**CITY OF WHITE SALMON
SUBDIVISION APPLICATION FORM**

Name of Plat Cherry Hill Estates

RE: Cherry Hill Estates Subdivision WS-SEPA-2024.001 – Consistency Review

Figure 3 Typical Cross-Section for Connector Street on the Bicycle Network

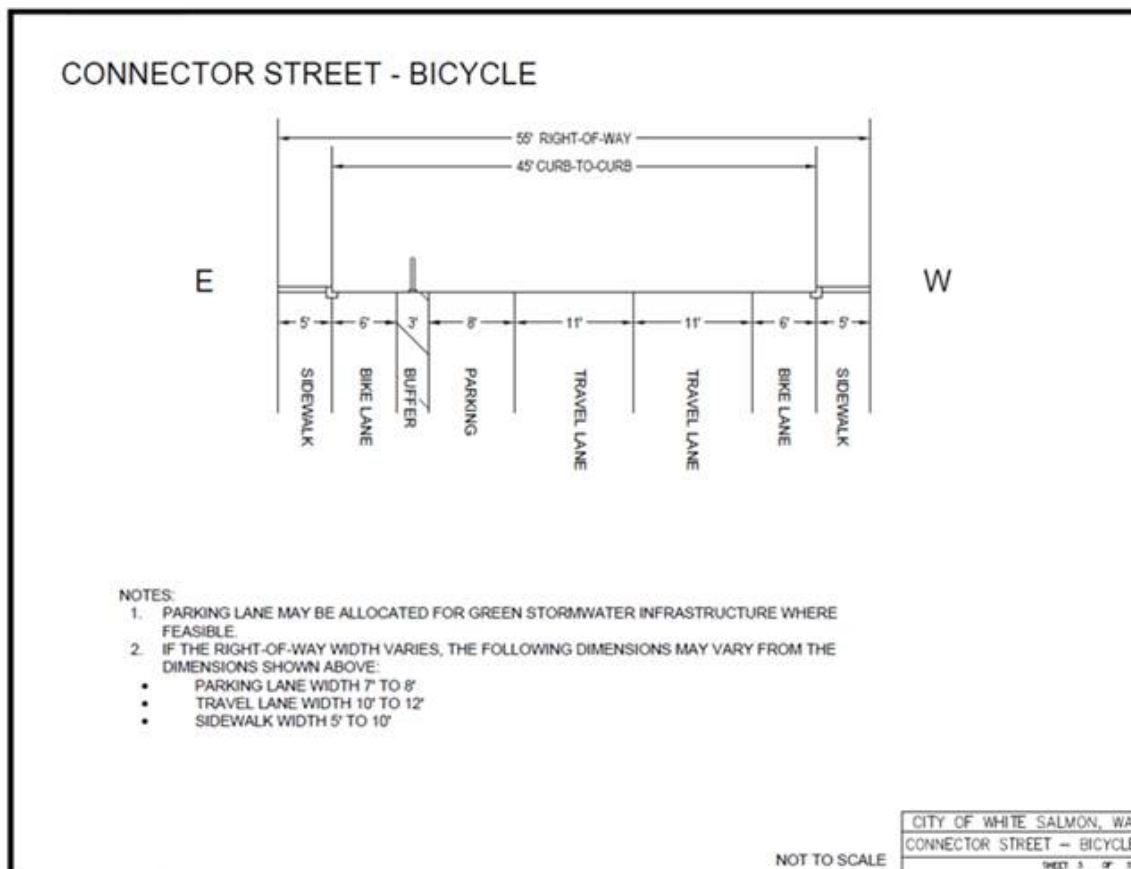
4. Per the City's recently-adopted Transportation Systems Plan (TSP) "Lite", (August 30, 2023), the City will require extended frontage improvements along NW Spring Street, per the adopted Safe Routes to School network shown on Figure 7 and described on page 3-10 of the plan (excerpt attached). This includes extending right-of-way frontage improvements east 127 feet from the project's entrance to where Lot 2 of the original Cherry Hills Estates Plat SP 91-17 terminates (1001 NW Cherry Hill Rd, parcel 03102475000200). Improvements must be installed or bonded prior to issuance of a future building permit certificate of occupancy.

Note, As shown in the attached Appendix C: Project List and Maps, NW Spring Street is a high-priority project for pedestrian and bike improvements. The City is currently applying for state funding to construct these improvements. If the City receives funding and constructs these improvements on the north side of NW Spring Street, the City may elect to waive this requirement. Please see the below cross-section from the City's TSP "Lite":

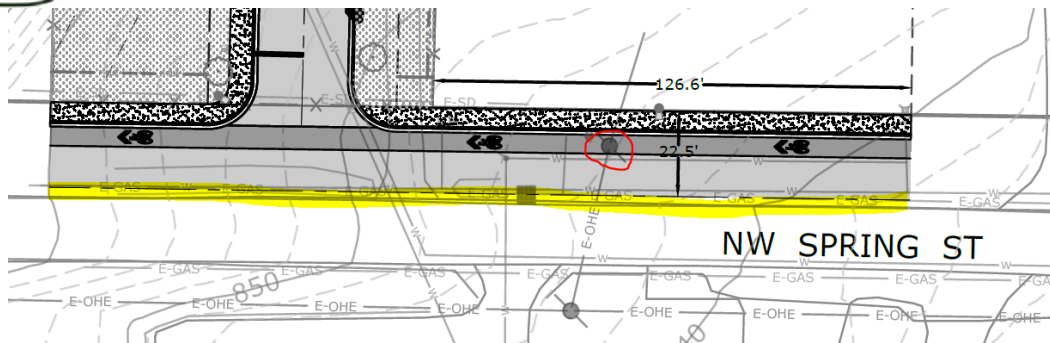
3. A full half street improvement on NW Spring Street is required, since there is no road base, and could otherwise create failures in the sidewalk in curb (see image below).
